ADDENDUM NO. 5

TO: PLANS AND SPECIFICATIONS FOR STATE OF MISSOURI

Renovate Mechanical / Electrical / Life-Safety / State Office Building
Jefferson State Office Building
205 Jefferson Street
Jefferson City, MO 65101
PROJECT NO. O1911-01

SHEET NUMBER:
MD3.0
 87 OF 244 SHEETS

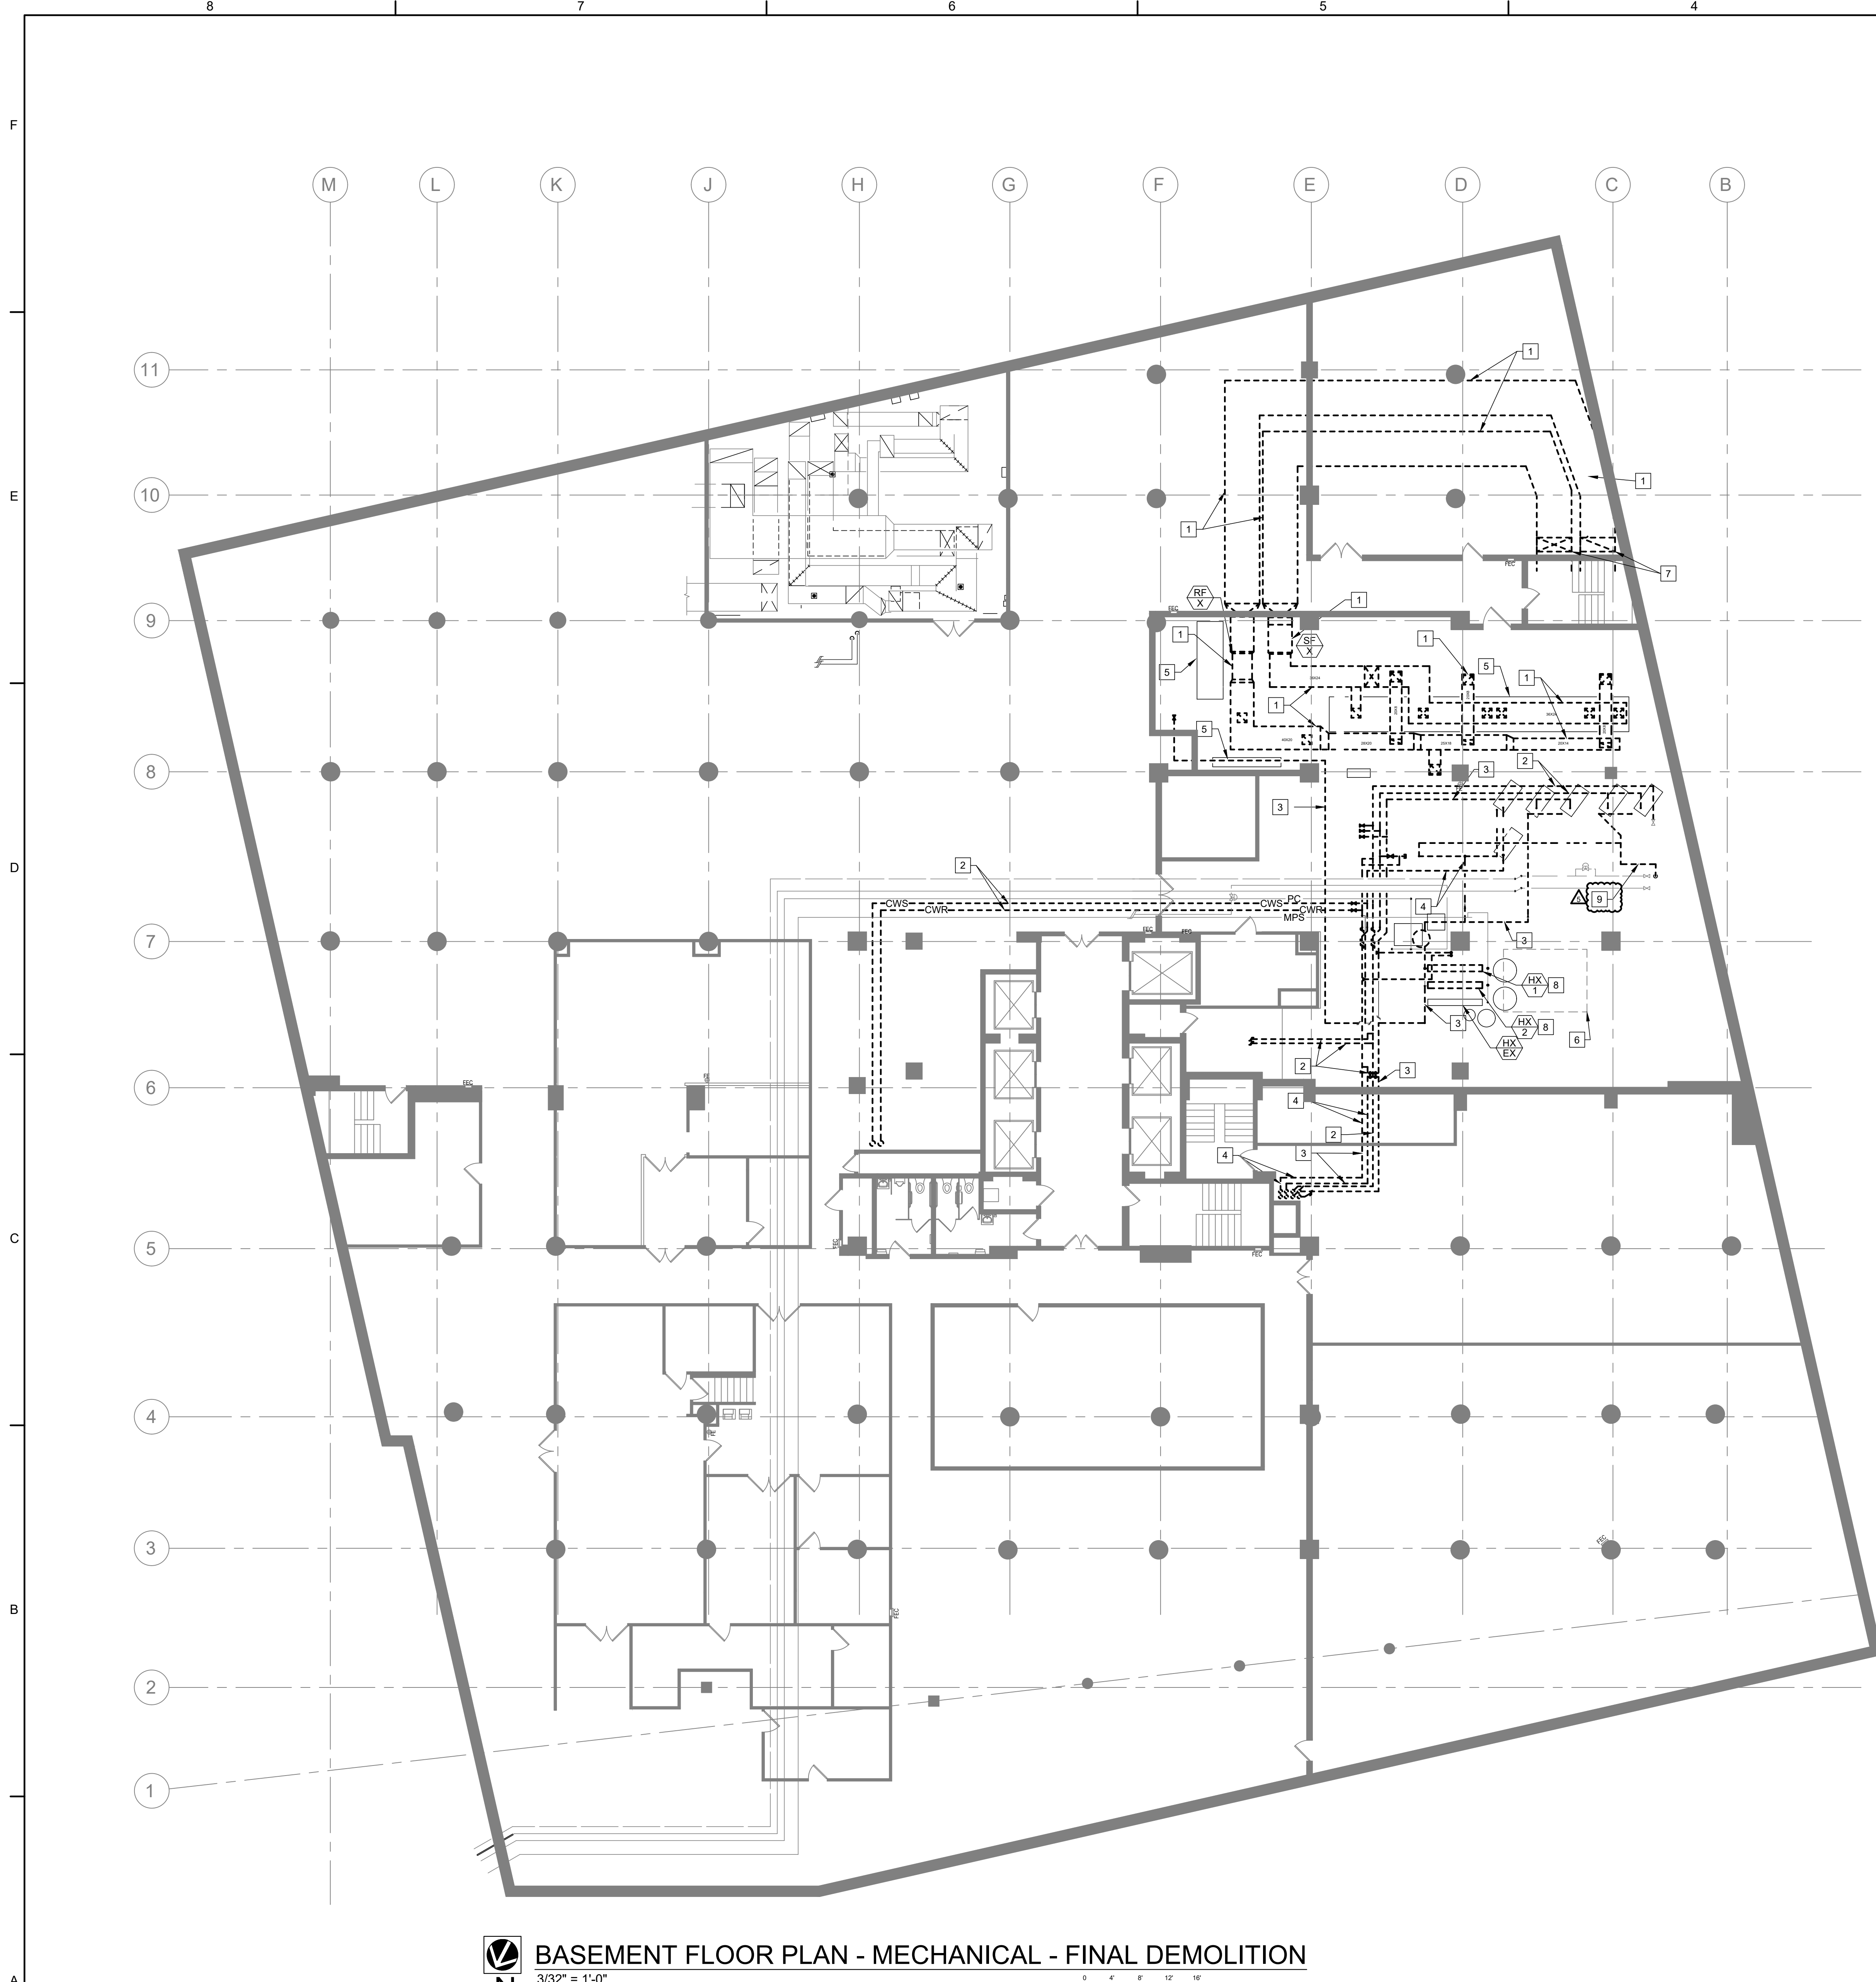
Response: Chiller and chiller piping will need to go. See attached asbestos report for base bid updates. See Sheet MD3.0 Keyed Note #3, MD3.2 Keyed Note #15, MD3.3 Keyed Note #14, and reference Hazardous Material Survey in Appendix.
